Secure 1000 Radiation Emission Measurement

FORM R-0646-1  
(Single Pose)

**Re: Rapiscan AIT System Radiation Survey Reporting**

## R-0646-1 Addendum (Documentation Errors)

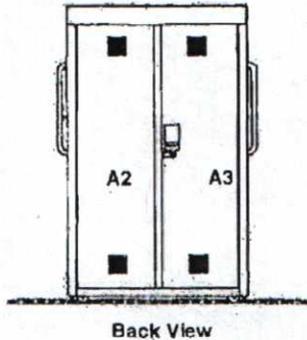
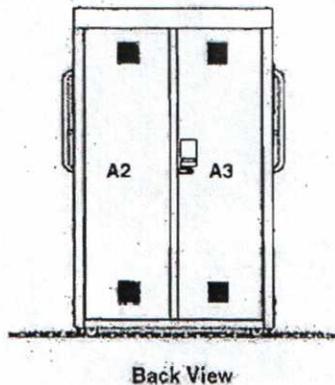
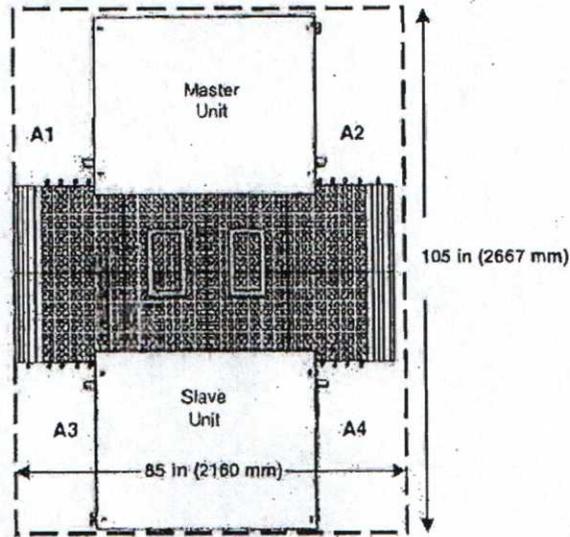
1. No value indicated for background radiation. Typical values range from 7uRem/hr to 13uRem/hr at sea level. Note: Absence of value has no adverse impact on calculations.
2. Technician indicated scan time as 7 seconds. Correct scan time is 3 seconds.
3. TABLE 1: Incorrect presentation of data in Column 3 for Measured Exposure. Indicated values are 39uR and 34uR. Corrected values are 3.9uR and 3.4uR. The values were corrected by technician when calculating Effective Dose.

The service technician should attend refresher training.

The corrected data indicates this system was operating within expected parameters. No re-survey is required for this system.
